Countywide Transit Corridors Functional Master Plan

Appendix 6
Stormwater Management

Subject: Stormwater Management for BRT Corridors in Montgomery County:
Response to Comments

Figure 6: Illustration of Wet Swale
 Source: MDE SWM Manual

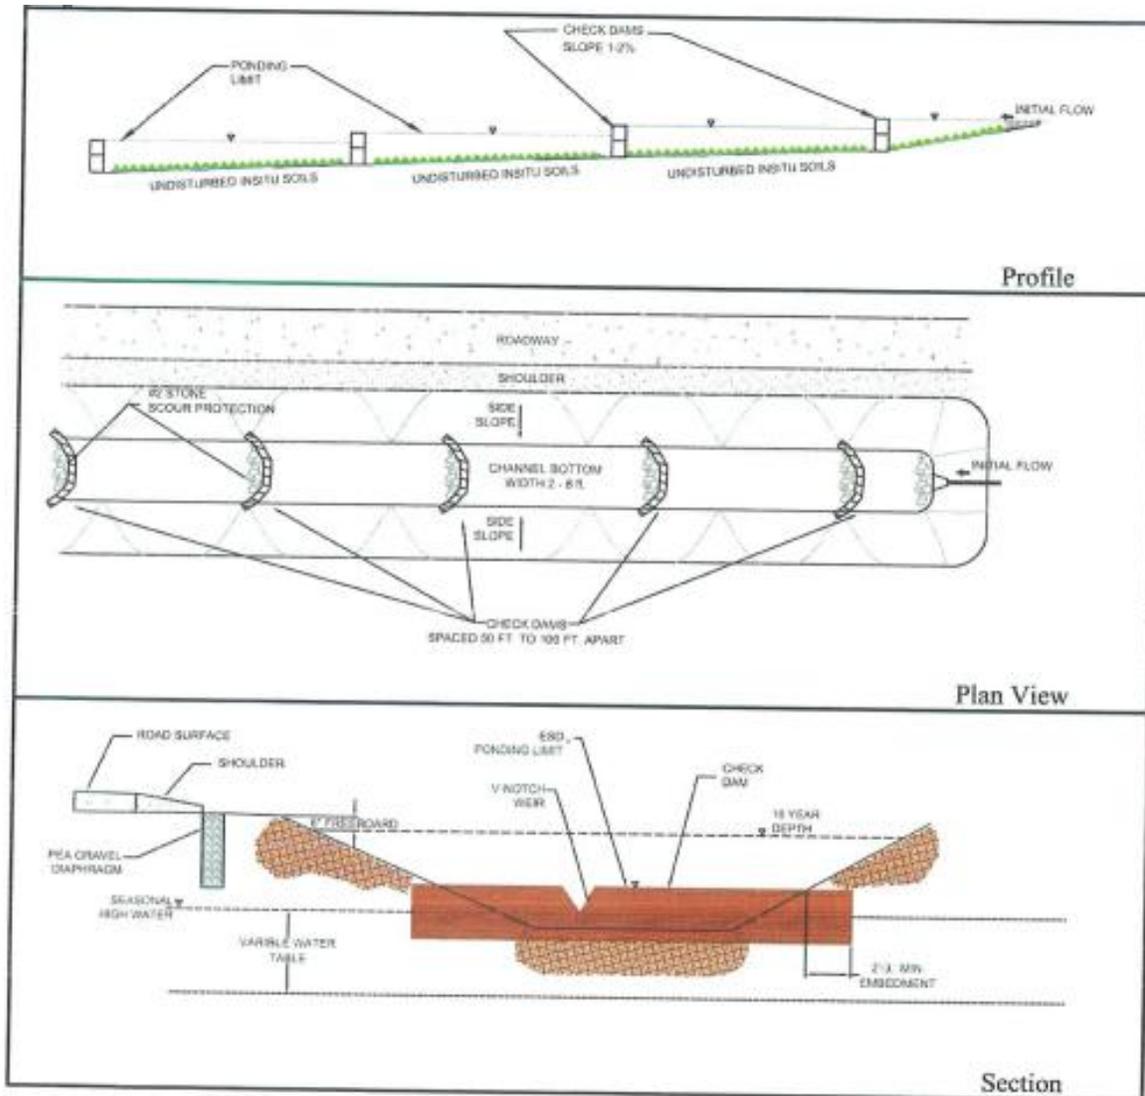
- Wet swales are not appropriate for the BRT line as the water table is not likely to be high enough in most areas and insects could be a nuisance.

PB Response: SWM facilities will be selected during final design depending upon the location of the alignment. The memo presents the different ESD options that can potentially be used along a BRT corridor.

Figure 8: SWM Typical Section using Water Quality Filter Strip
Source: PBNetwork, May 2009

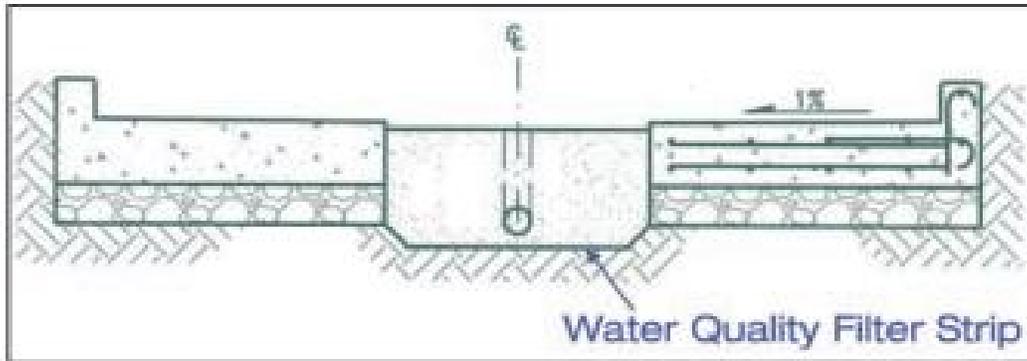
- Not a standard MDE approved practice (sand filters): May require additional testing.
 - M-NCPPC Response: MDE has not rejected “Green Streets”. A Green Street is a street with any stormwater treatment. MDE will approve a ‘Green Street’ if the treatment facility(s) (whichever ones they are) are sized correctly.

- M-NCPPC Response: A Green Street does not have to be or have a sand filter; it can have any approved stormwater treatment facility/device.

- Requires plant establishment which is difficult due to free-draining layer of sand
 - M-NCPPC Response: As noted above, a Green Street does not have to be a sand filter and thus planting does not have to be limited.

PB Response: Comment noted. To avoid confusion with any SWM treatment that can be accommodated within the streetscape, we have renamed the phrase “green street” to “water quality filter strip,” to accurately reflect the treatment being described. Although MDE has not rejected the idea of water quality filter strips, the feasibility and viability of the same is still being tested in several cities in US. Maryland Transit Administration is currently studying the concept for the Red Line project. The key to the concept of the water quality filter strips is that vegetation be maintained in the filter strips and that the filter media should allow free draining of runoff and not creating ponding. Also, further design guidance will need to be coordinated with the designers, Montgomery County and MDE.

PB Response: Agreed. The water quality filter strip can be of any material and does not necessary have to be a sand layer. The key to the concept of the green street is that vegetation be maintained in the filter strips and that the filter media should allow free draining of runoff and not creating ponding and create a traffic hazard. There are very limited choices of the approved ESD stormwater management treatment facilities that will qualify for this application.

PB Response: Please see response stated above.

Figure 9: Illustration of Permeable Pavements
 Source: MDE SWM Manual

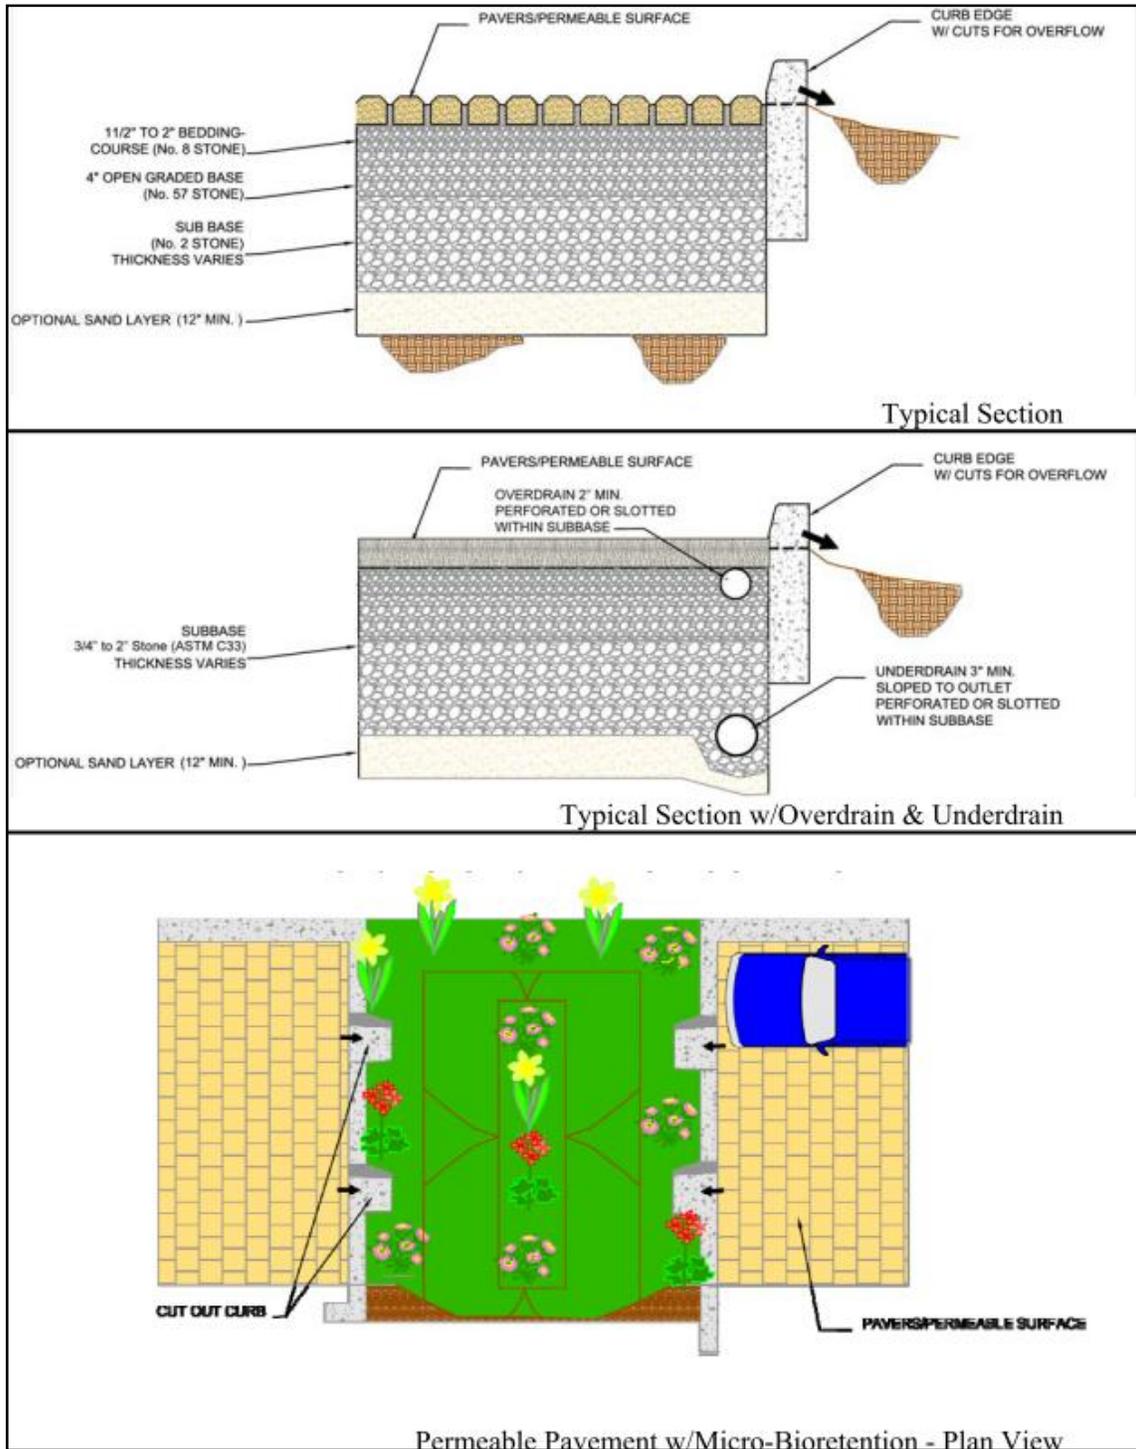
- Permeable pavement is recommended only in areas where the soils types are sandy or silty having hydrologic soil groups of A, B or C.
 - M-NCPPC Response: Soil types C and D drain slowly or not at all. These soil types are often found in compacted urban soils. In these situations soil types C and D does not preclude the use of permeable pavements. A routine practice is the use of an underdrain to which allow for water catchment, containment, and the slow release of water into the stormdrain system.

- The subsurface water table will help determine the stone reservoir thickness used.
 - M-NCPPC Response: The stone reservoir depth is determined by the storage treatment volume goals. However, if there is a high water table (not likely along the BRT line), then there would be a shallow reservoir or none at all.

- Maintenance is a major issue. Typically permeable pavements require regular vacuuming (usually every 6-8 weeks) to prevent sediments from clogging within the voids of the pavement.
 - M-NCPPC Response: Permeable pavements have come a long way. The void spaces are quite large now and many manufacturers recommend vacuuming once or twice a year. Some have even gone so far as to say no vacuuming is necessary (Flexi-pave).

- Cannot be used in areas having poorly drained soils or where the ground water table is high.
 - M-NCPPC Response: See response above pertaining to soil groups.

- During winter, there is a possibility of ice being formed in the voids of the pavement which can cause damage.
 - M-NCPPC Response: Multiple years of installation and testing has not shown this statement to be true.

PB Response: Comment noted. Chapter 5 of the MDE manual (Page 5.48 –Supplement 1)) states that permeable pavements should not be installed in HSG D or on areas of compacted fill. The MDE manual also recommends using perforated pipes in non-HSG D areas as an additional measure to ensure that the runoff is intercepted and conveyed to the storm drain system.

PB Response: Agreed. The stone reservoir depth is determined by the storage treatment volume goals as well as the ground water table. This will be determined during final design.

PB Response: Comment noted. Permeable pavements need periodic maintenance depending on its type and application. The type of permeable pavements to be used will be determined during final design and maintained as per the manufacturer's approved specifications.

PB Response: Comment noted. Chapter 5 of the MDE manual (Page 5.48 –Supplement 1) states that permeable pavements should not be installed in HSG D or on areas of compacted fill. The MDE manual suggests using perforated pipes to ensure that the runoff is intercepted and conveyed to the storm drain system.

PB Response: Comment has been removed. Chapter 5 of the MDE manual states that all permeable pavements shall be designed to ensure that water surface elevations for the 10-year storm do not rise into the pavement to prevent freeze/thaw damage to the surface. This should be confirmed with the manufacturer when selecting the surface during final design.

Figure 10: Illustration of Filterra Bioretention System

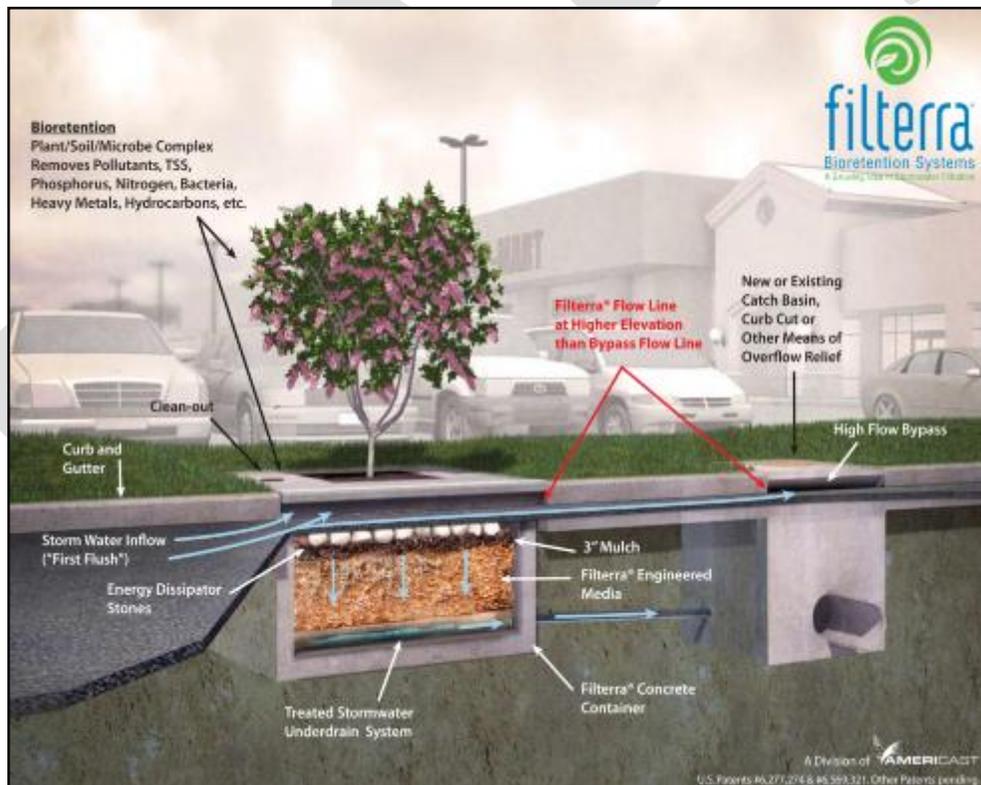
Description Paragraph: “This bioretention device is not an approved MDE device and may require additional coordination with the manufacturer to receive MDE approval. “

- M-NCPPC Response: A recent conversation with Brian Clevenger (MDE, Stormwater and Sediment Control) has stated that Filterra systems are an approved MDE stormwater treatment device.

- Maintenance needs to be provided by the manufacturer on a semi-annual basis.
 - M-NCPPC Response: Annual maintenance is required.

- Not a standard MDE approved practice.
 - M-NCPPC Response: See above comment pertaining to MDE approval.

PB Response: Filterra is an approved MDE device to treat 1” of runoff. However, during a presentation with Filterra in during late 2010, Filterra was still trying to work with MDE and get an approval so that their products could be used for ESD. The ESD guidelines suggest that the target rainfall may need to be as high as 2.6” and a minimum of 1” of runoff needs to be treated through ESD to MEP. If the entire target rainfall (P_E) runoff cannot be treated, supplemental facilities will need to be provided. PB is working on getting a response from Filterra as to their current status with MDE on the ESD criteria.

PB Response: Comment agreed. This will be confirmed during our coordination with Filterra.

PB Response: Comment noted. Filterra is manufactured device and not a traditional standard SWM device.
